IEEE 802.3cg
Clause 148 cleanup
September 9th, 2019

- During the initial SA ballot phase there have been a number of comments asking for clarifications and fixing state diagram semantic. These were mainly related to:
 - Timers and tolerances
 - Clocks & timings definition
 - Execution order of state diagram statements
 - Operators precedence
- None of these comments was intended to change the functionality being described
 - But they introduced a few editorial and technical regressions
- Several individuals with different affiliations worked in background to stabilize the draft
- This presentation shows the final changes that have been checked and validated by all parties

#1: BEACON is not sent (fix)

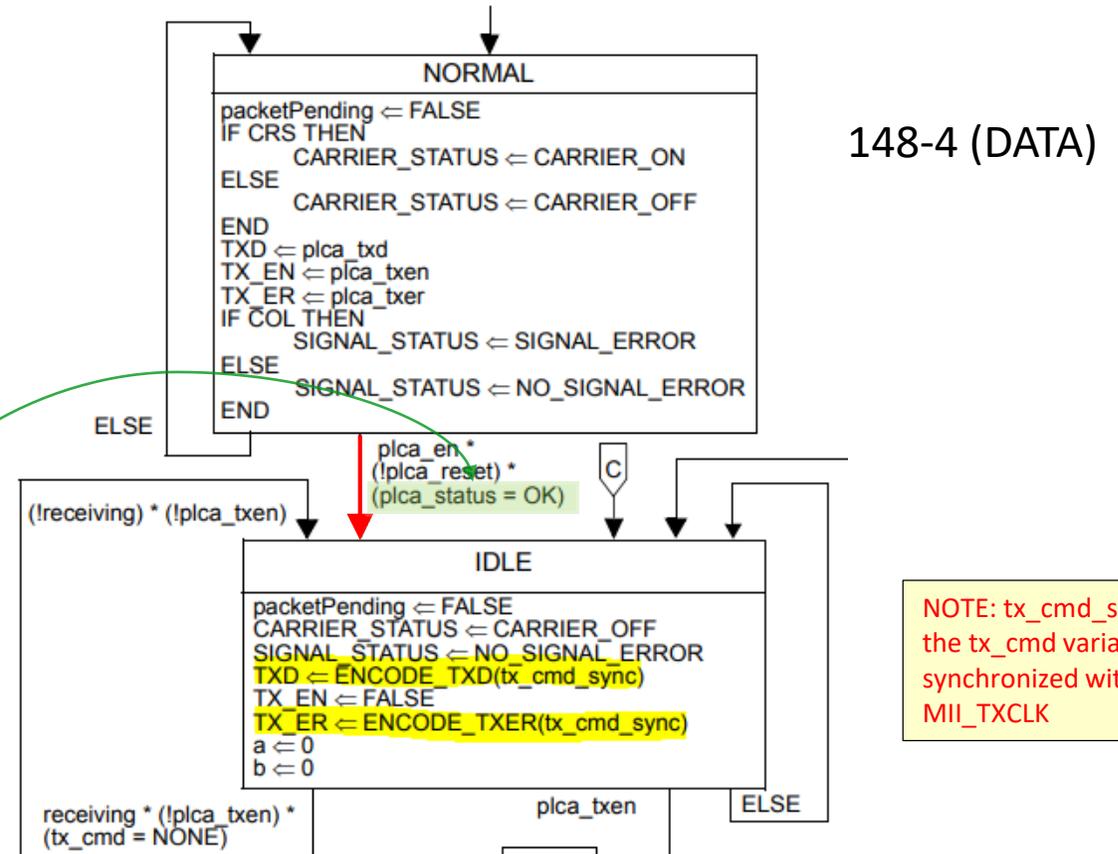
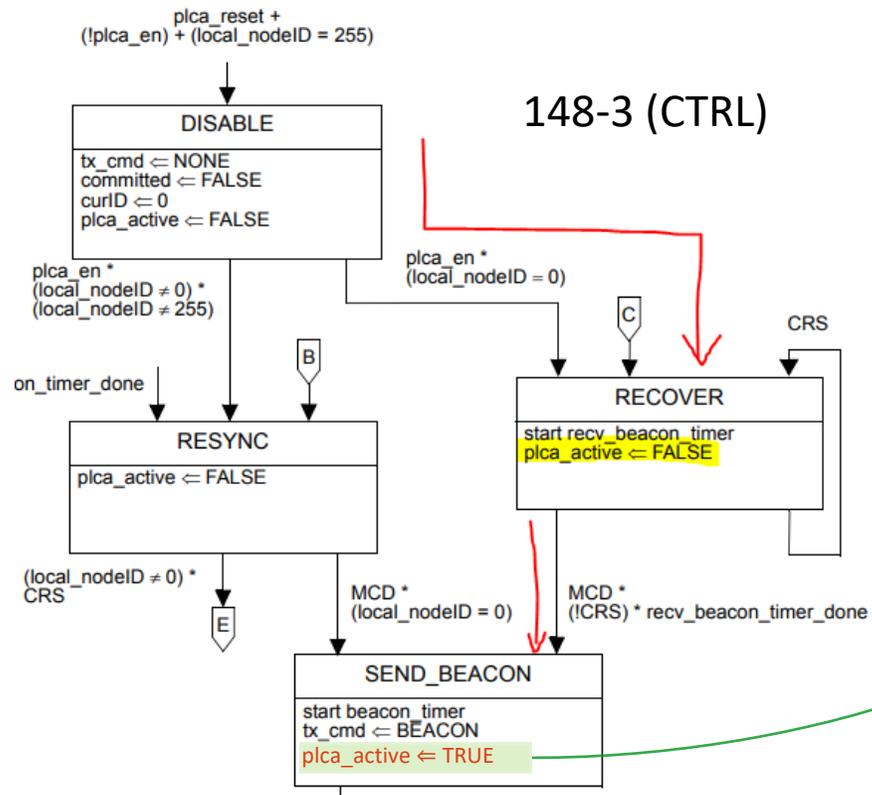
#1: BEACON is not sent

- When PLCA is disabled, `plca_status` is not OK
 - The PLCA Data State Diagram is held in NORMAL state
 - in NORMAL state the MII signals are driven by the MAC directly (normal CSMA/CD w/o PLCA). They cannot convey BEACON or COMMIT requests to the PHY.
- When PLCA is enabled for the first time, the node with `ID = 0` sends a BEACON, as described in the PLCA Control State Diagram
 - since `plca_active` is FALSE, the DATA State Diagram remains in NORMAL state and does not send the BEACON

The simple fix is to set `plca_active` TRUE in `SEND_BEACON` state

This makes the `DATA` State Diagram progress to `IDLE` state, where the `BEACON` is conveyed as intended

#2: packets not sent in burst mode

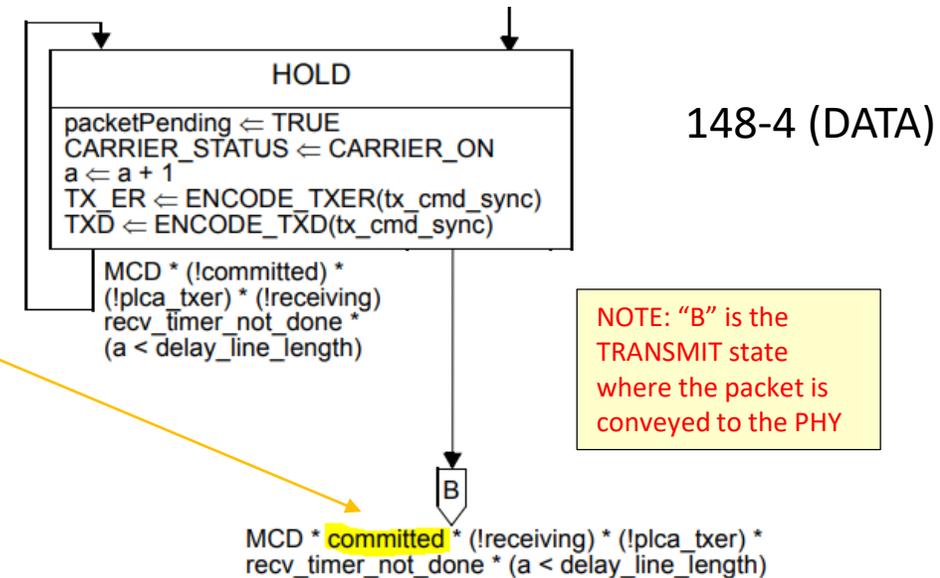
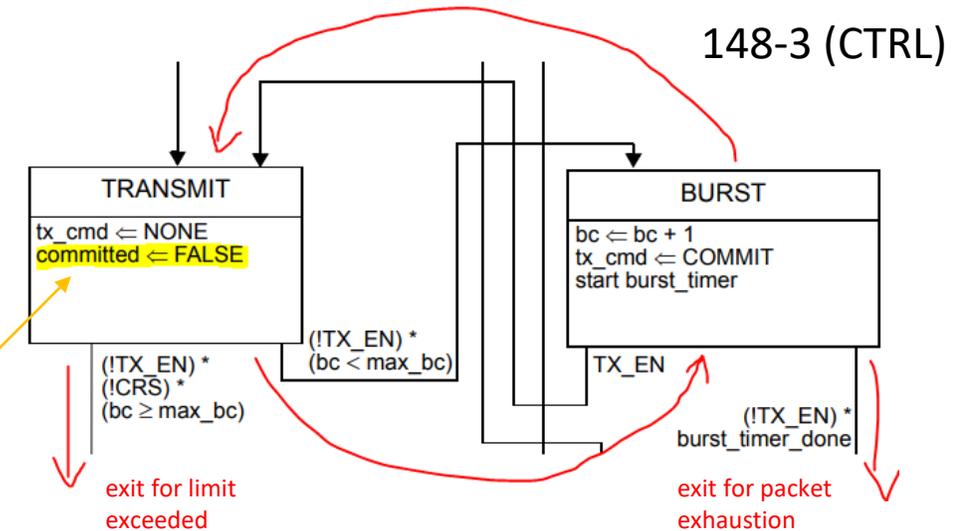
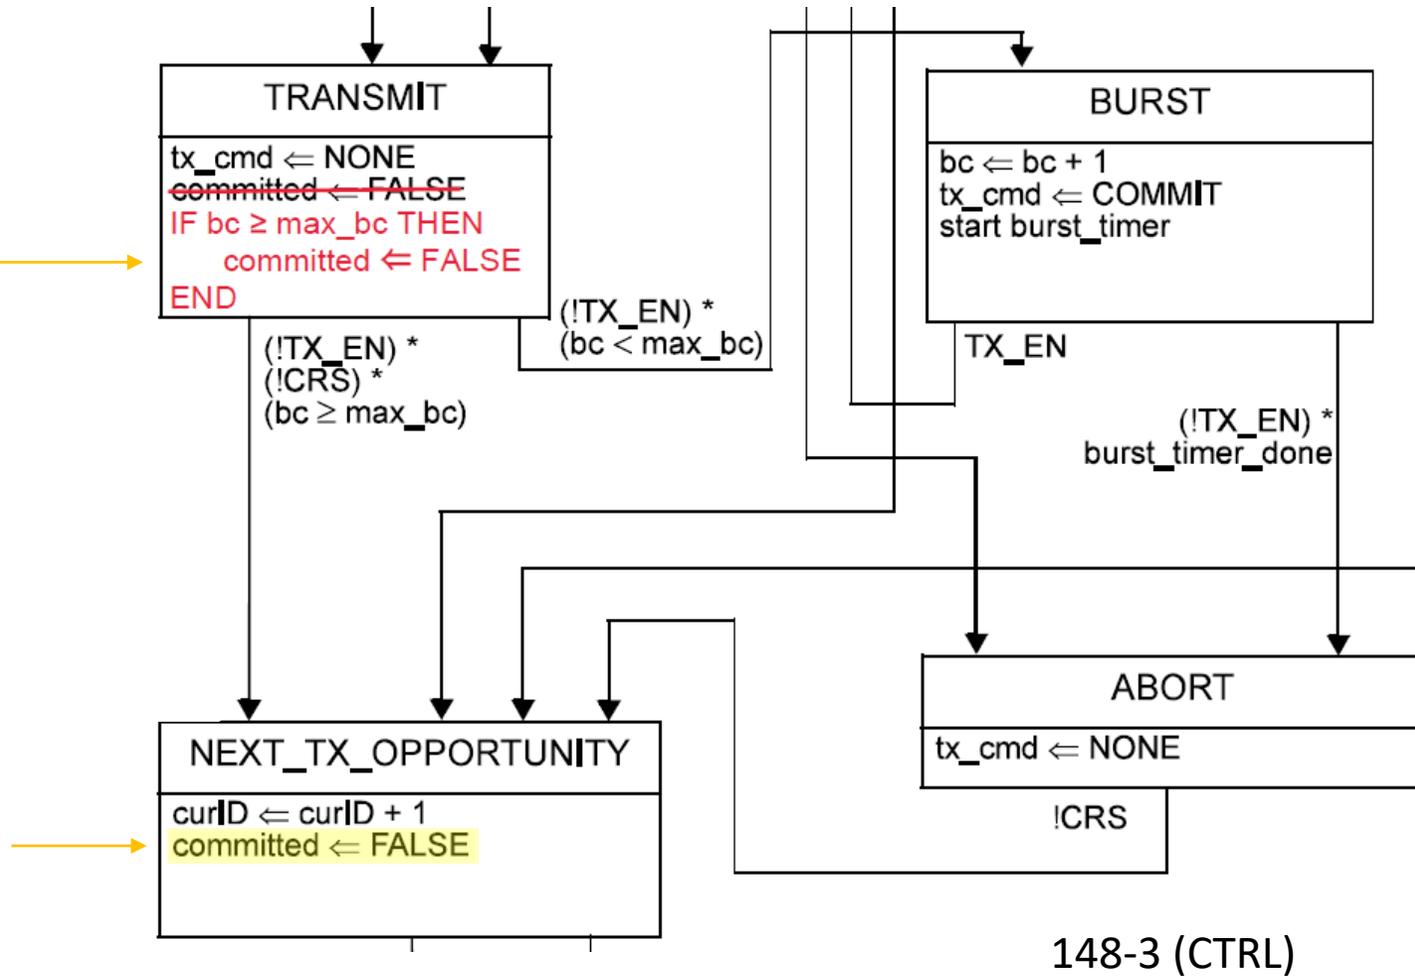
- When burst mode is enabled ($\text{max_bc} > 0$) the PLCA Control State Diagram loops between TRANSMIT and BURST states until the MAC has no more packets available to send, or the configured burst limit is reached.

— Note that the “committed” variable is set to FALSE

- The DATA State diagram, however, requires the “committed” variable set to TRUE to progress to the TRANSMIT state.

The simple fix is to prevent the “committed” variable to be reset while a burst is in progress.

In case the burst ends because the MAC has no packets available, the “committed” variable is also reset (this is already part of the draft)

148-4 (DATA)

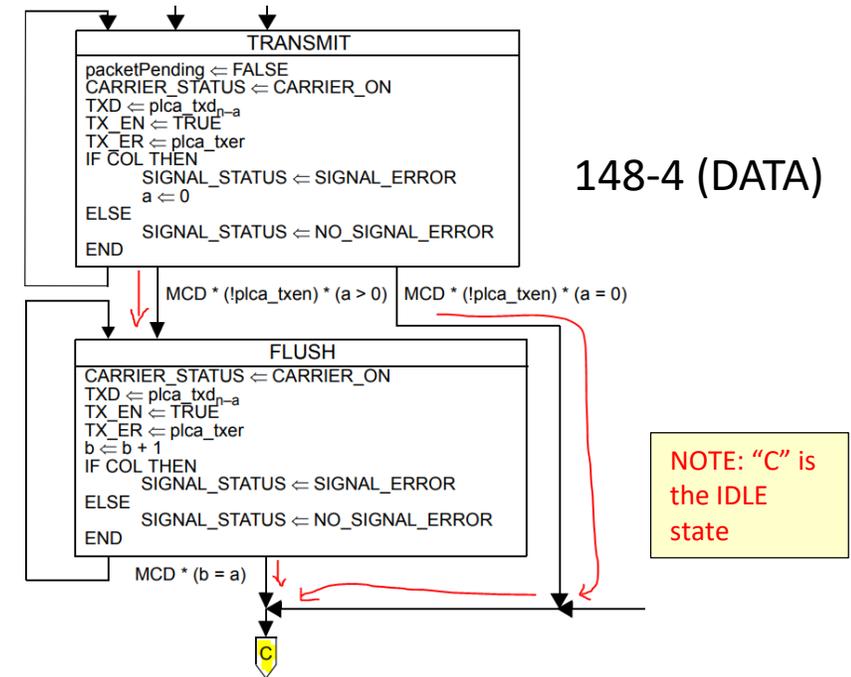
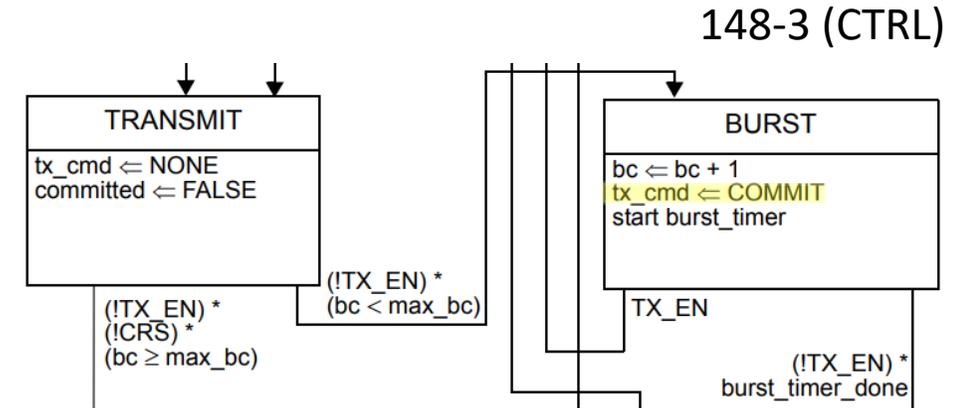
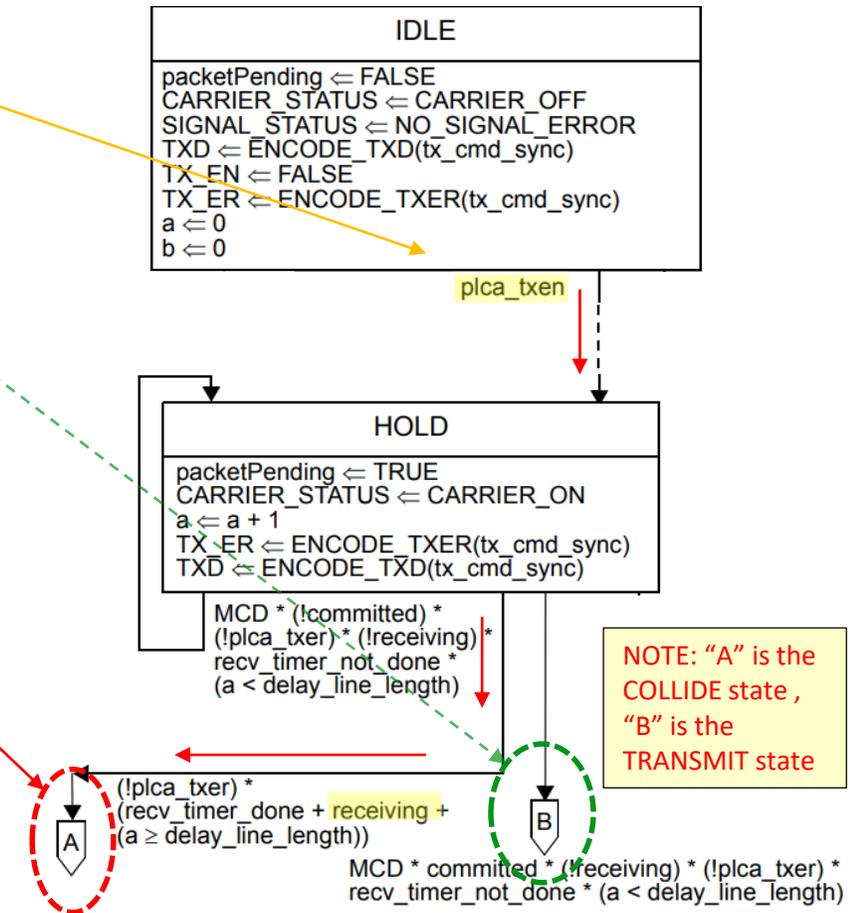
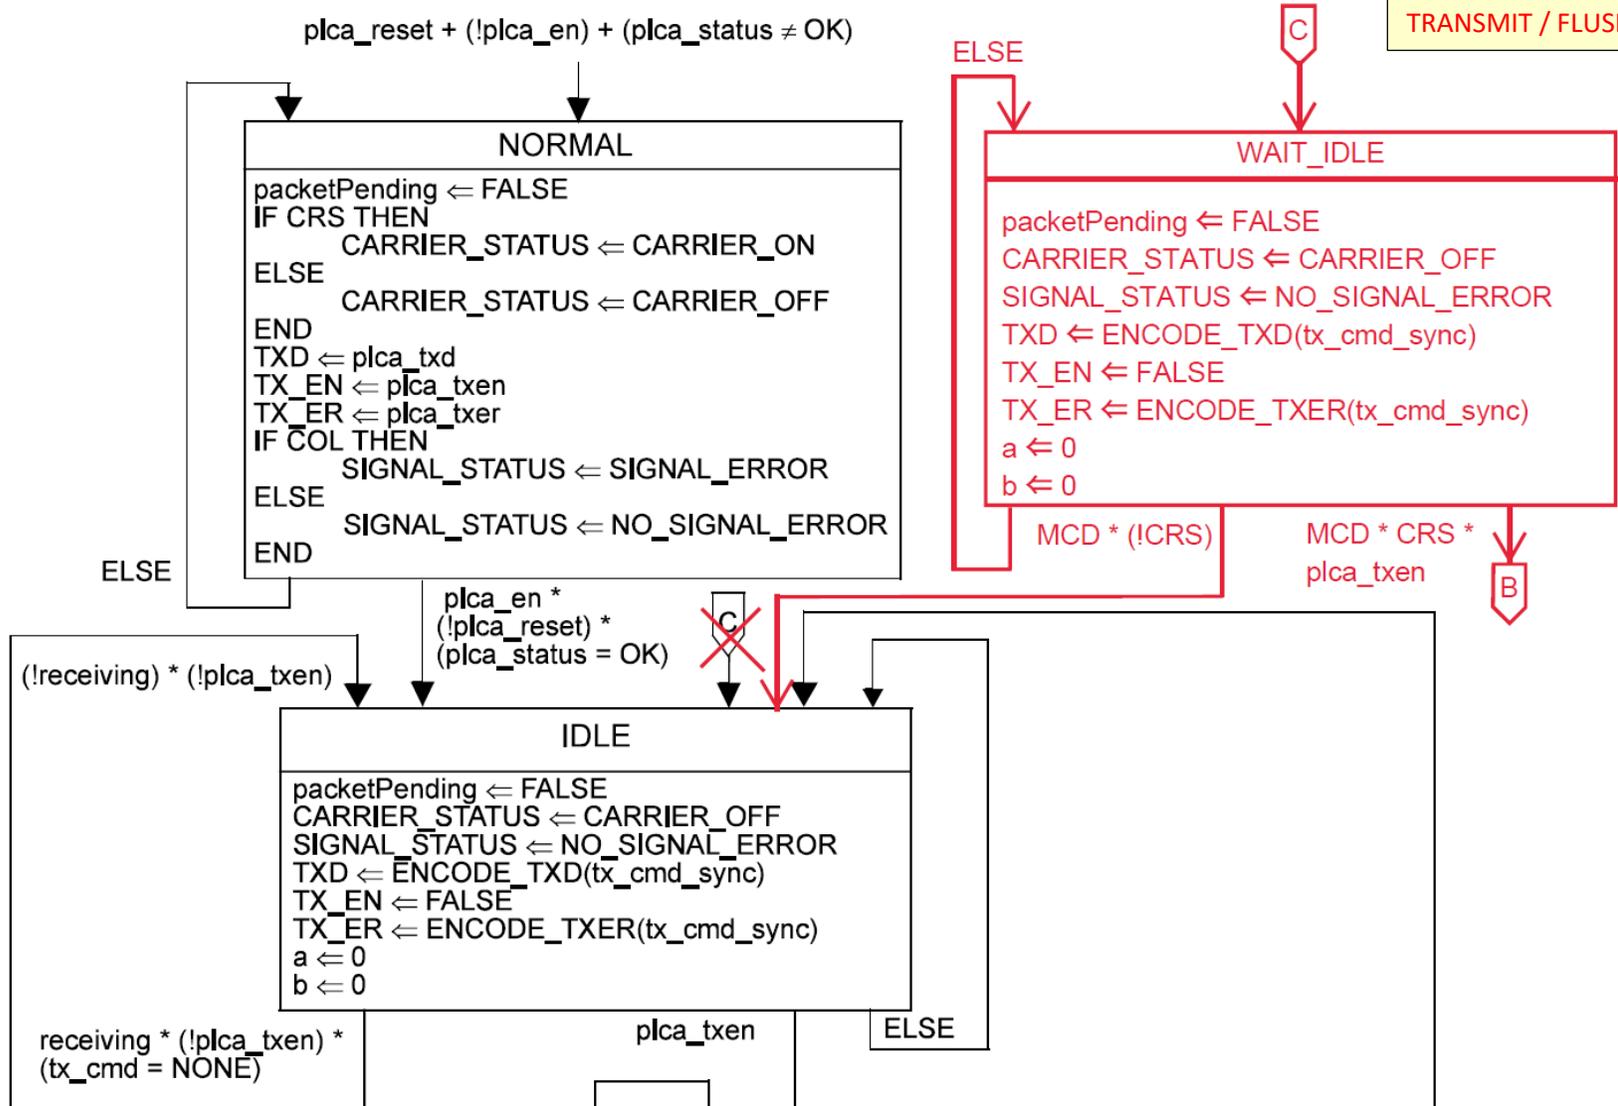
- During a burst, the IPG is filled by COMMIT (IDLE symbols) to keep the transmit opportunity. See http://www.ieee802.org/3/cg/public/Nov2018/buruto_3cg_PLCA_burst_mode_revB%20.pdf.
- This is done by setting $tx_cmd = COMMIT$ while the Control State Diagram is in the BURST state.
- After the first packet is sent, the DATA State diagram moves from TRANSMIT/FLUSH to IDLE state. This happens as soon as the delay line is empty and the MAC is done sending data.

- The DATA state diagram from IDLE will move to HOLD as soon as the MAC transmits the next packet.
- From HOLD state the DATA State Diagram is supposed to progress to the TRANSMIT state to have the PHY sending the packet on the line.
- However, depending on the PHY RX latency, the “receiving” variable *maybe* TRUE at that time because of the COMMIT request being looped back into a COMMIT indication
 - This would make the DATA State Diagram report a false collision to the MAC.

The fix may look complicated but it is simple: have the DATA State Diagram wait for the line to be free (CRS = FALSE) before going to IDLE. Go back to TRANSMIT (B) if bursting.

This is easily done adding a state (WAIT_IDLE) which does the same as IDLE but also detects a burst and goes to TRANSMIT as appropriate.

Note that during a burst the CRS is not de-asserted (it's the working principle of the burst mode), therefore the transition from WAIT_IDLE to B can only happen during such event. When NOT bursting, the transition from WAIT_IDLE to IDLE will always occur earlier than one IPG, ensuring proper behavior in normal conditions.

148-4 (DATA)

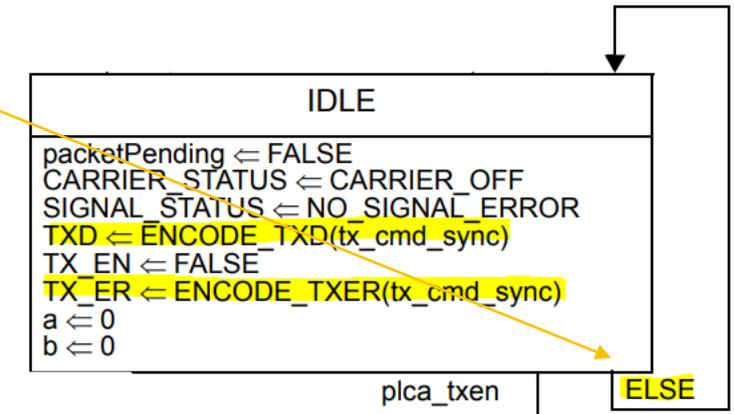
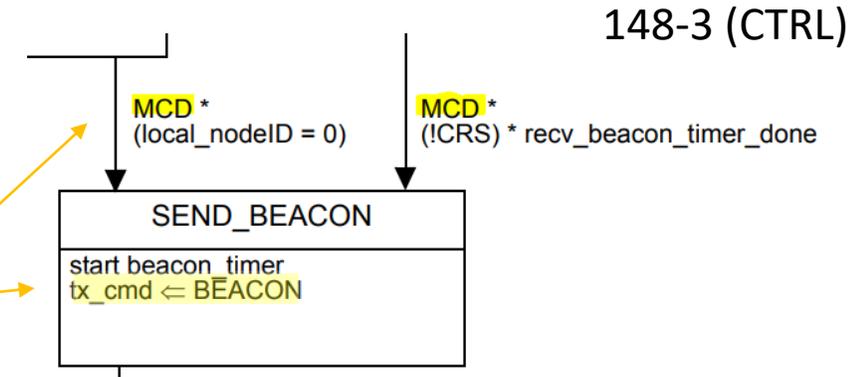
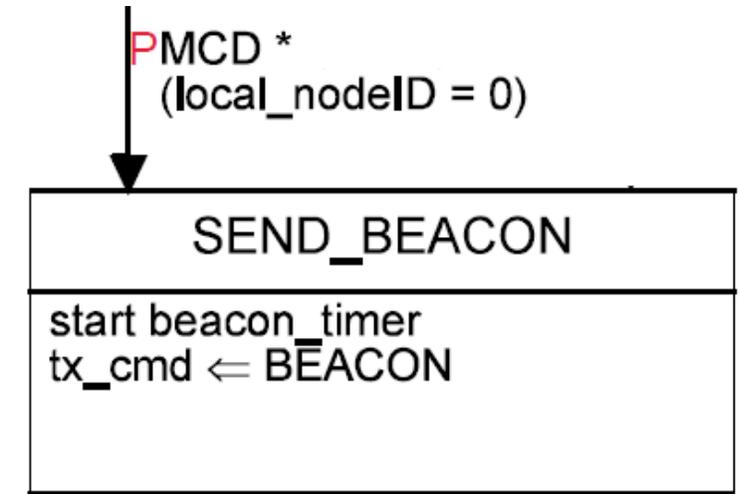
- According to Clause 22.3.1 the MII signals going from the RS to the PHY (TXD, TX_EN, TX_ER) shall be output from 0 to 25ns after the rising edge of TX_CLK.
- The SEND_BEACON state in the Control State Diagram is entered on the rising edge of TX_CLK (MCD), and the tx_cmd variable is set accordingly.
- The DATA State Diagram, which drives the MII signals, refreshes itself when the tx_cmd_sync variable changes.
- The tx_cmd_sync variable is defined as the sampling of tx_cmd on the **falling** edge of the MII TX_CLK.
- Since the TX_CLK clock period for 10 Mb/s is 400ns, this refresh may occur 200 ns later than the rising edge, which violates the requirement in 22.3.1 (see first bullet).

- The fix is twofold
 - Define tx_cmd_sync to be updated on the **rising** edge of the MII TX_CLK
 - This ensures the MII timings are met
 - Add a “prescient” MCD (PMCD) which occurs slightly earlier than MCD
 - This compensates for the extra clock cycle between the CONTROL and DATA State Diagrams, keeping the latencies within the required range

Prescient mii_clock_done function.
This function becomes done
 $1 \pm \frac{1}{2}$ bit times earlier than mii_clock_done
